Sent: 11/12/2025 12:41:38 PM
From: Luis Martinez <luis.martinez@flocksafety.com>
To: Sing, Soratha@DOT, "Bobby" , "Derek" , "Wendy Stratton"
Cc: Lee, Jae-Myung@DOT, "Hayley"
Bcc:
Importance: Normal
Subject: Re: 423899 - Benicia PD - Encroachment Permit Application; 0424-NSV-0053
Attachments [image001.png](#) , [image002.png](#) , [image003.png](#)
: [image004.jpg](#) , [image005.png](#)

From: Sing, Soratha@DOT <soratha.sing@dot.ca.gov>
Date: Wednesday, November 12, 2025 at 8:56 AM
To: Bobby Sokolowski <bobby.sokolowski@flocksafety.com>, Derek Porcella <derek.porcella@flocksafety.com>, Wendy Stratton-Monahan <WMonahan@ci.benicia.ca.us>
Cc: Lee, Jae-Myung@DOT <jae-myung.lee@dot.ca.gov>, Luis Martinez <luis.martinez@flocksafety.com>, Hayley Goodman <hayley.goodman@flocksafety.com>
Subject: RE: 423899 - Benicia PD - Encroachment Permit Application; 0424-NSV-0053

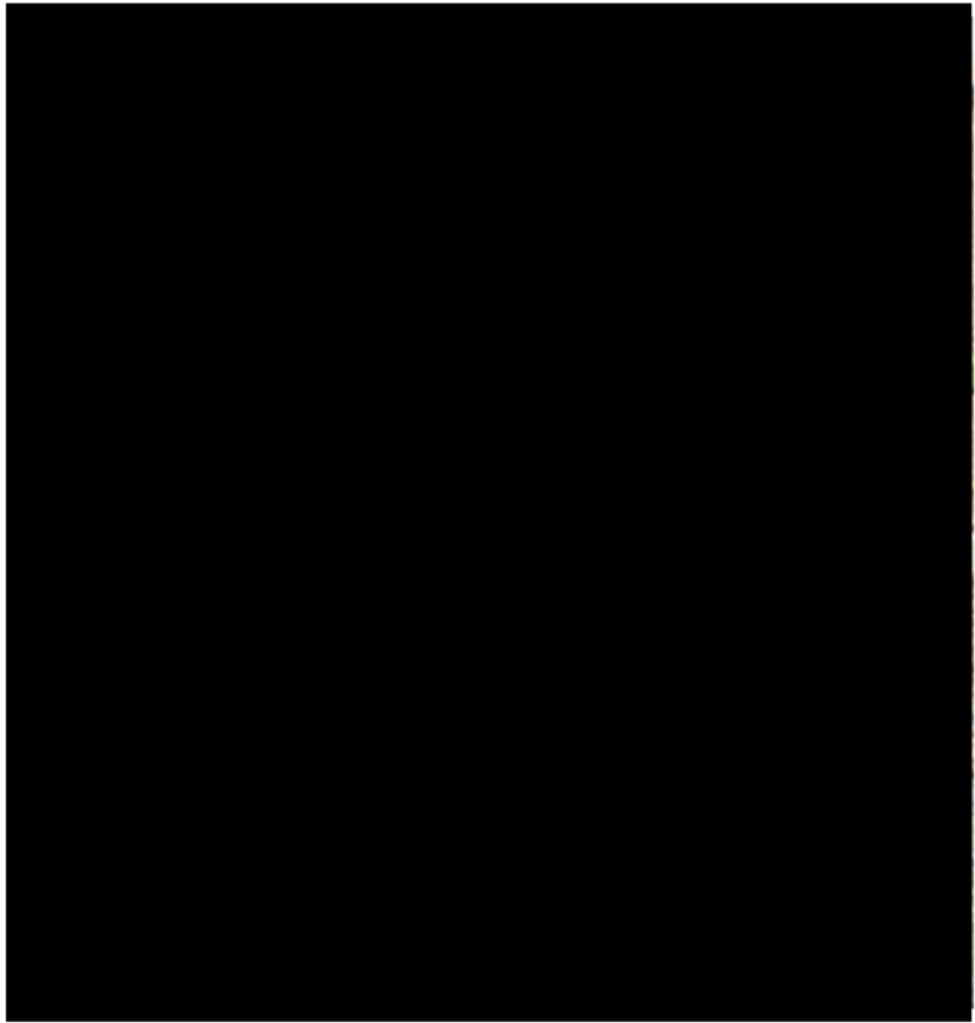
The submitted calcs (pages 5 and 10) assumed current Std Plan dimensions. However, it is my opinion that the existing pole is an older type.

Please provide **As-Built of the existing light pole** (see image below).

There is an aluminum identification tag on the existing pole.

And from that, one can determine:

- Year of the original construction and/or Year of Std Plans, and
- Pole Type.

Please provide the existing pole information and dimension or as-built for further review.

Here is a picture of the pole tag. Do we need to use a different standard than the 2018 plan ES-6A?

What year standard should be used?

Type 15-97

Valmont 2009
